## **HARBOURSIDE SHOPPING CENTRE REDEVELOPMENT, DARLING HARBOUR (SSD 7874)**

### **SUBMISSION ON BEHALF OF THE OWNERS OF STRATA PLAN 49259 (50 MURRAY ST)**

**SSD 7874 Redevelopment of the Harbourside Shopping Centre  
Addendum to Presentation made to the Independent Planning  
Commission**

Figure 1  
Principle for more appropriate view sharing  
(Adapted from part of Page 3, FJMT Supplementary Architectural Design Report)

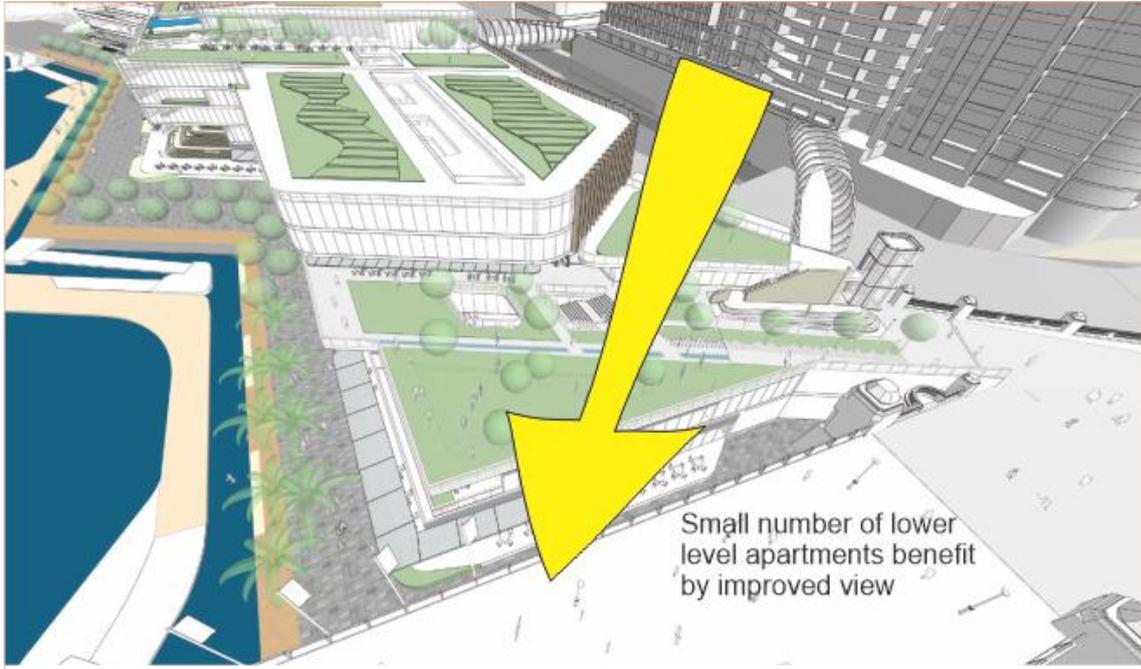
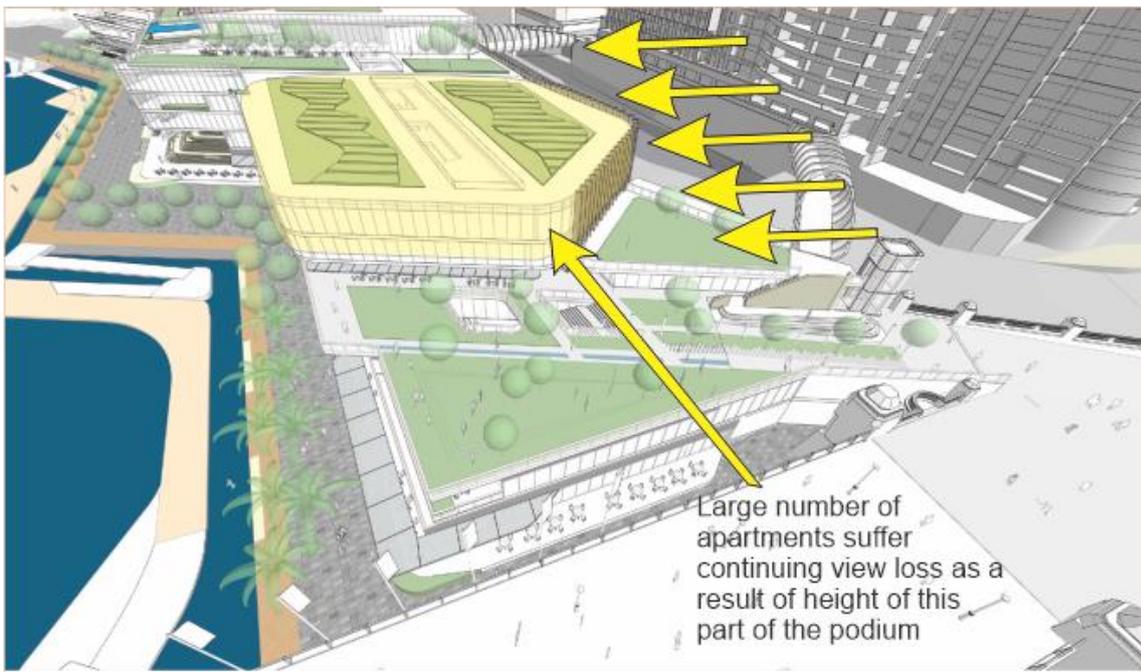
The figure below that I adapted from the Supplementary Architectural Design Report by FJMT prepared for Mirvac shows eloquently what the massive and over-height northern section of the podium does to views from 1 Darling Harbour. The upper two storeys of the area coloured yellow, in what is described in the Draft Development Consent as the Northern Podium Articulation Zone, is the culprit in causing unreasonable view loss to levels of One Darling Harbour that currently have whole, water views of Darling Harbour.

The shape of the area in plan that is proposed to be included in the potential Guardian Square plaza is of limited benefit in view sharing to One Darling Harbour. This is illustrated in the figure above and in the photomontages prepared by Virtual Ideas. However, the lower podium is an improvement to the views from a small number of units, that is appreciated.

Reconsideration of the height, the function and the likely future character and height of items that could be approved on this part of the podium could provide a satisfactory outcome for One Darling Harbour in terms of view sharing.

Figure 1  
Principle for more appropriate view sharing  
(Adapted from part of Page 3, FJMT Supplementary Architectural Design Report)

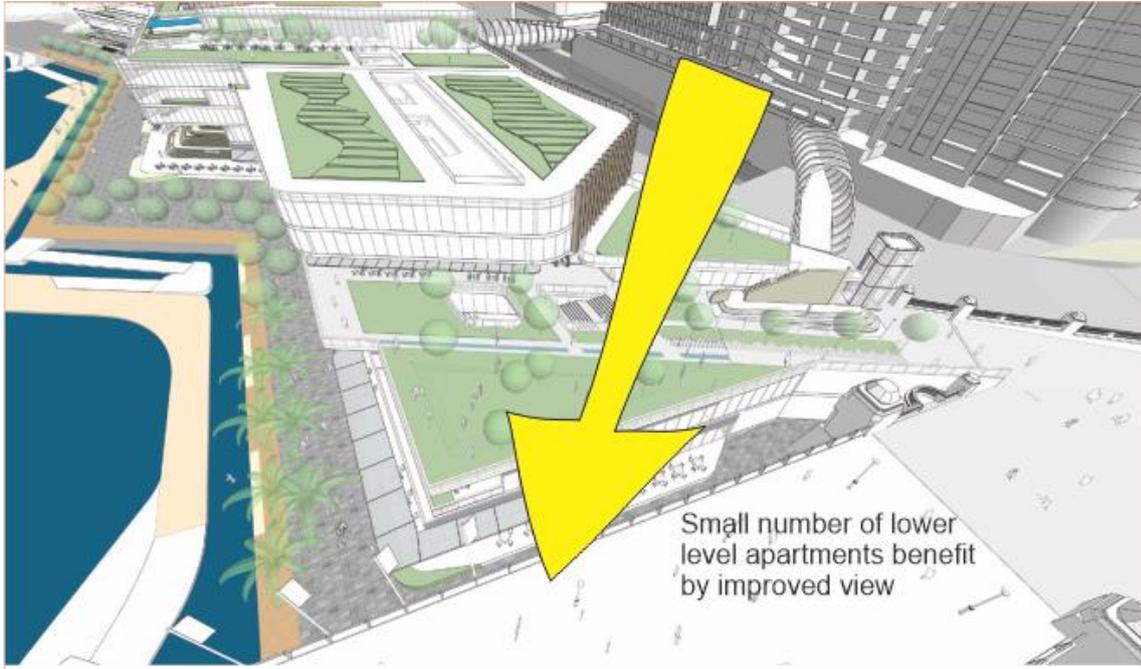
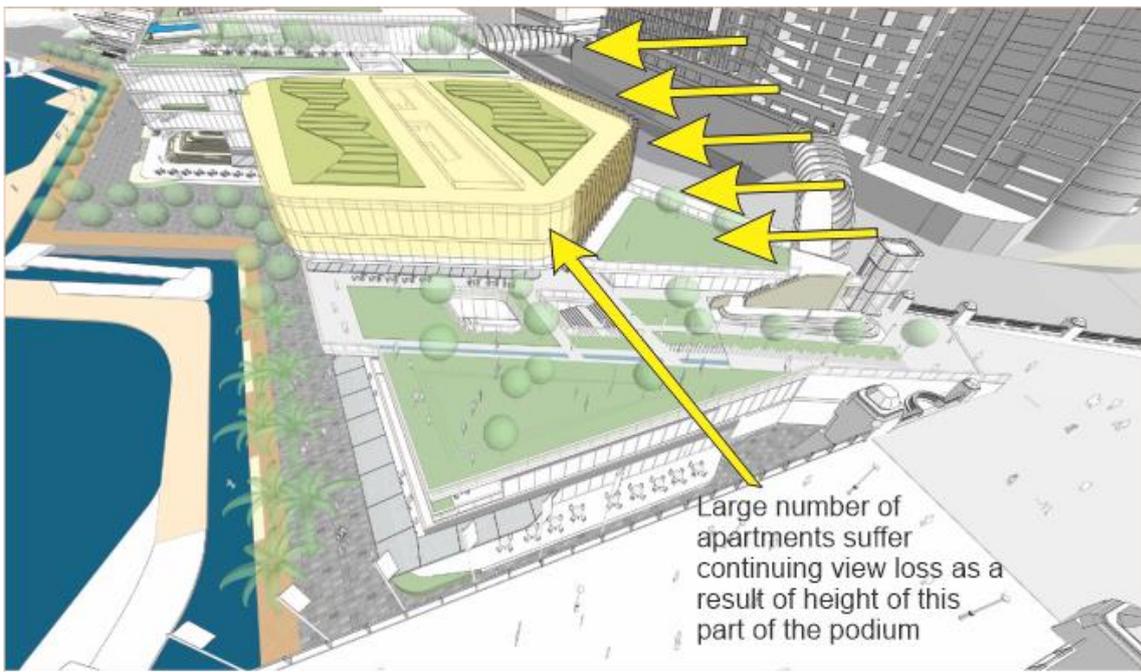
The shape of the area in plan that is proposed to be included in the potential future plaza is such that it is of limited benefit in view sharing however, as it is at its narrowest toward One Darling Harbour and the part that extends more widely to form the plaza and link to Harris Street is largely out of view, blocked for most apartments by the higher part of the north-east section of the podium. The main reasons for the shape of the 'cut out' on the podium appear not to be primarily to achieve view sharing, although there is a minor benefit there, but are the alignment with a formal link to Harris Street, space for a link across Darling Drive to One Darling Harbour and a link to the foreshore.

The lower podium is an improvement to views from One Darling Harbour that is appreciated, but the benefit should be extended by moving the south boundary of the lowered section of the podium further south and on an alignment more directly easterly, for example to the alignment of the next step in height in the podium that is proposed further to the south.

I have noted the part of the podium that is still of concern with regard to view sharing with One Darling Harbour on Figure 1 below, by means of a transparent yellow fill on a graphic adapted from Image 31 from the FJMT Supplementary Architectural Design Report. The slot in the podium benefits a small number of apartments, whereas the height of the part of the podium shaded yellow causes continuing unreasonable view loss for a much larger number. Reconsideration of the height of this part of the podium could provide a satisfactory outcome for One Darling Harbour in terms of view sharing.

An extract from the "Envelope Plan – Podium" dated 11/2/20 is provided below<sup>6</sup>:

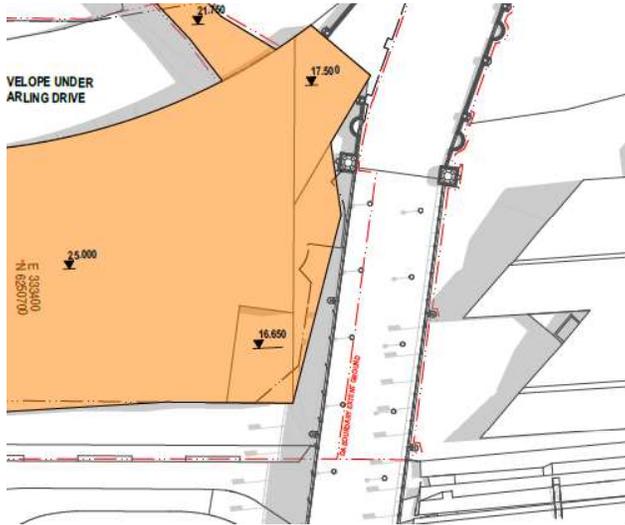
- The proposed building envelope will almost touch the envelope of the pedestrian walkway of Pyrmont Bridge;
- The relative height of the bridge is not specified. However, it appears that the pedestrian walkway of Pyrmont bridge is between 11.5m RL- 13.m RL and the railings are at between 12.5m-14m RL<sup>5</sup>.
- The northern podium will be primarily at 25m RL. The podium will be approximately 7m distant from the bridge at this height. The "lower" triangular segments of the podium (which sit closer to the bridge) are to be 16.5m RL (on the harbourside) and 17.5m west of the bridge buttresses. The height of the proposed podium sliver most directly adjacent to the bridge is not specified.

The podium areas closest to the bridge are actually **higher** in this proposal than in the original proposal. In the original proposal the majority of the northern podium was to be 23.8m RL.

A copy of an extract for the approved Cockle Bay plans is below:

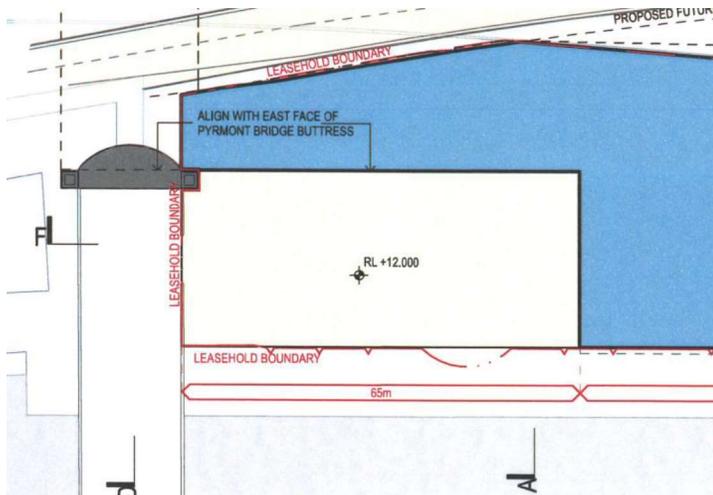
We contrast this proposal with the building envelope approved for the Cockle Bay Wharf Redevelopment (SSD 7684) on the eastern side of Pyrmont Bridge. In that instance, the project application initially sought approval for a building envelope including a tower close to Pyrmont Bridge. In the amended (and subsequently approved application) the tower envelope and podium area was moved, *inter alia*, to provide a more appropriate relationship with Pyrmont Bridge. Relevantly, the approved podium envelope is restricted in height to 12m RL on the western (water) side of the bridge buttresses and 19m RL east of the bridge buttresses. The 12m RL height restriction extends for 65m along the western edge before the envelopes steps up to 29m RL for the tower podium.

*Proposed Envelope*

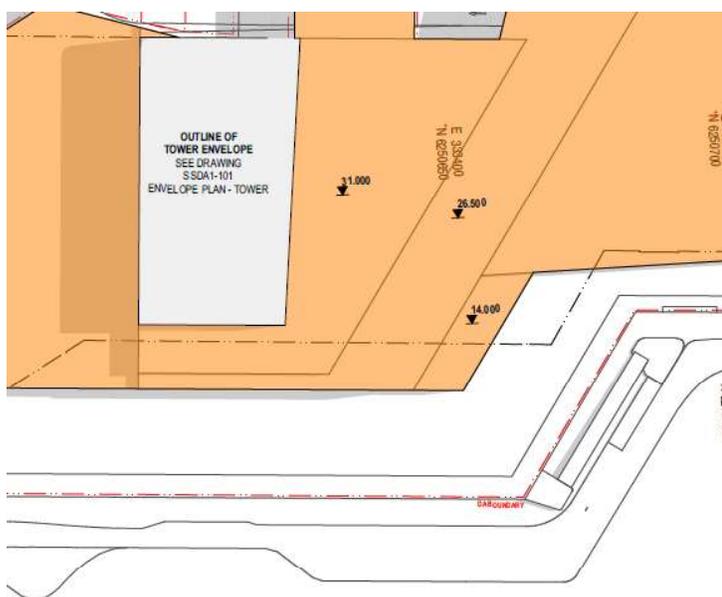
Set out below are extracts from the “Existing Site Plan” and the “Building Envelope Plan”. The black hashed line is the boundary of Lot 1. Lot 1 is relevantly land leased by the proponents under a 99 year lease. The existing Harbourside building sits within the boundary of Lot 1. The orange form in the second image is the proposed building envelope which sits at least 10m east of the Lot boundary closest to the proposed tower. We note the proposed DA boundary is marked in red.

We assume from these images that not only will it be necessary for the permitted use of the site under the existing 99 year lease to be amended but also, and more importantly, for the State government to gift a strip of “core” public waterfront land to the proponent.

**ATTACHMENT B – COMPARISON OF IMAGES: INTERFACE WITH PYRMONT BRIDGE**

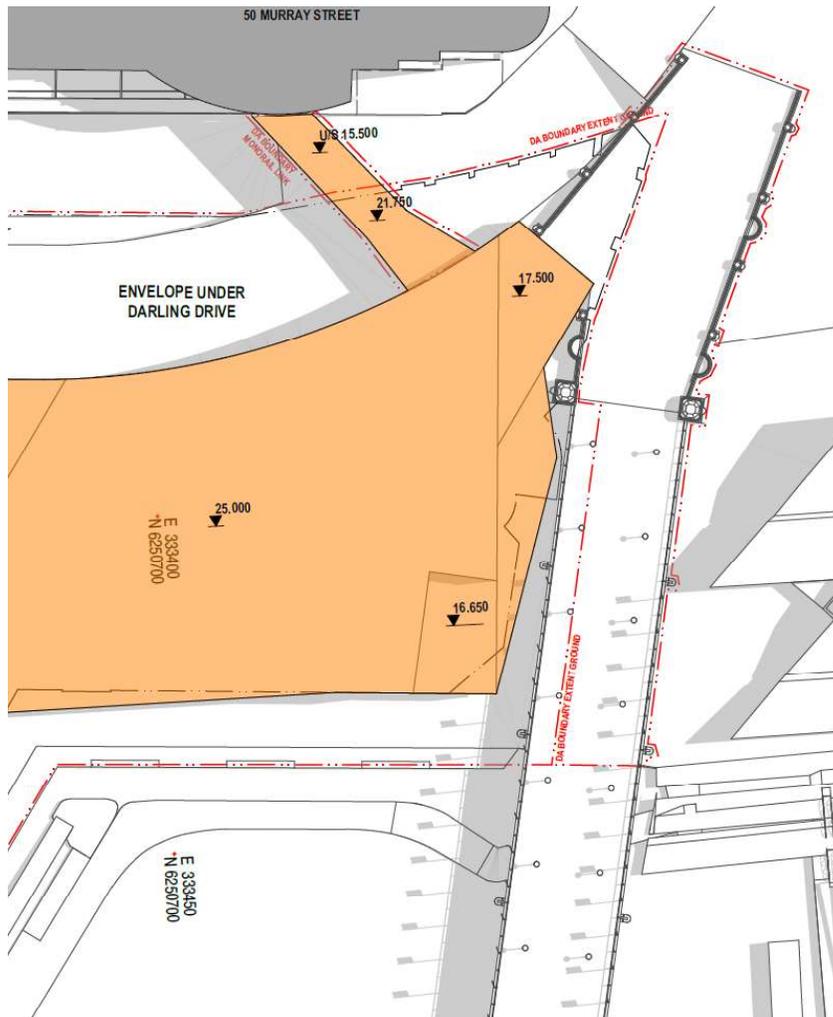
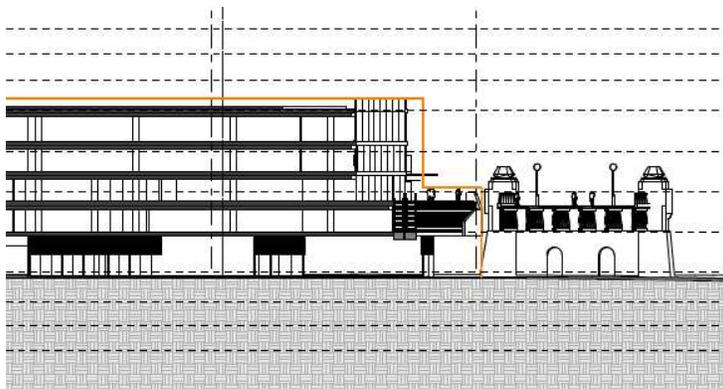
We have already detailed above (in section 4) the inconsistencies in the various depictions of the relationship between the northern podium and Pyrmont Bridge. Some of these images are reproduced in Attachment B. Dr Lamb (in Attachment A) has identified further issues with the distortion of images provided by Virtual Ideas and used in the VVIA and other reports and their lack of relevance and credibility for the assessment of private view impacts and/or impacts on public domain views. We further note, for example, that figures 22 and 23 in the Urbis report provide different impressions of the proposed use of the rooftop of the northern podium (which would directly affect the view impact for our client).

*Figure 31 (Urbis Report)*

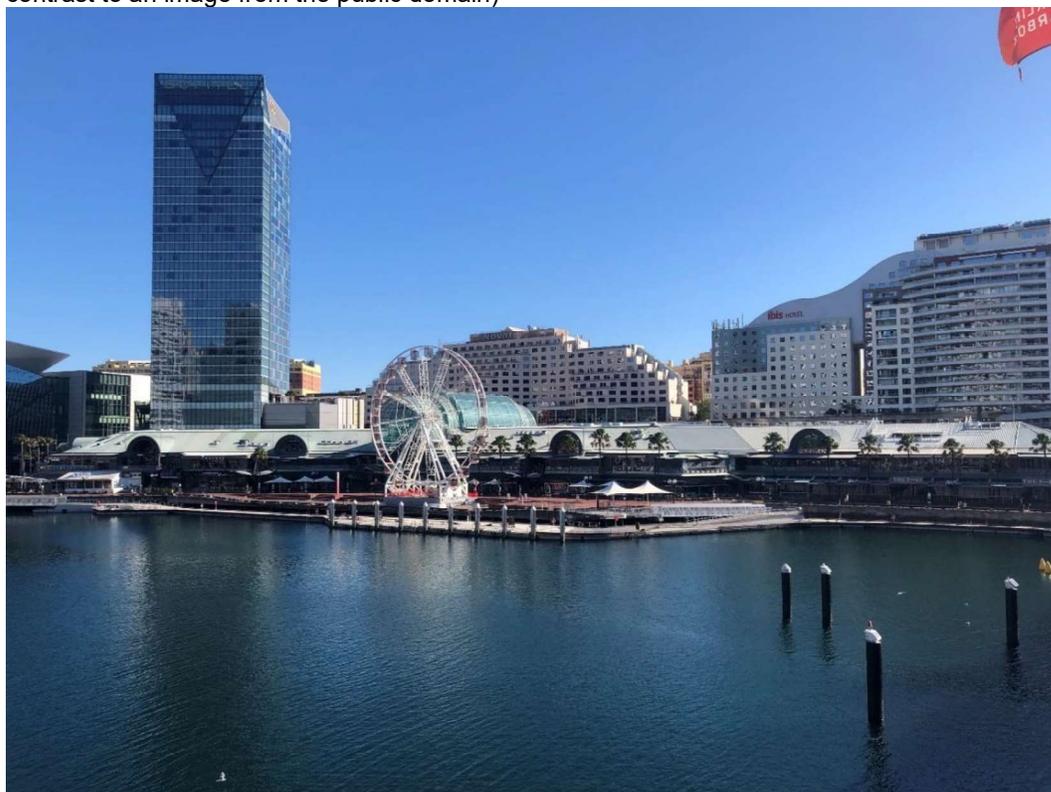
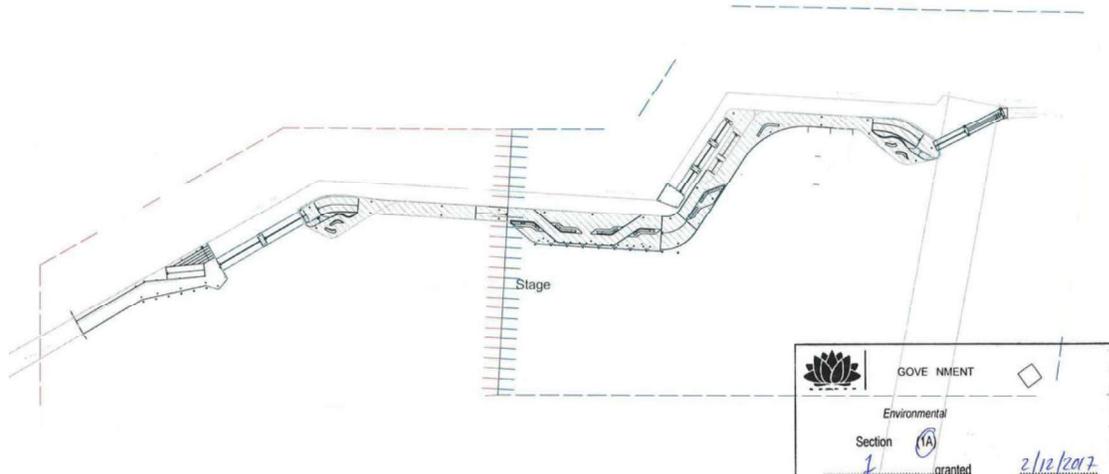
We have set out in **Attachment C** two contrasting images of the proposal. Figure 31 from the Urbis Report providing a drone public domain image and an equivalent photograph taken by our client from Pyrmont Bridge. We note Figure 31 appears to significantly over- represent the public domain area east of the development, and suggests an articulation of the setback of the tower podium at the ground floor and a separation of podium elements not provided in the building envelope plans and provides

(Note the depicted depth of the proposed promenade and the configuration of the pontoon promenade. Also note the different relative sense of height and bulk provided by an aerial image in contrast to an image from the public domain)
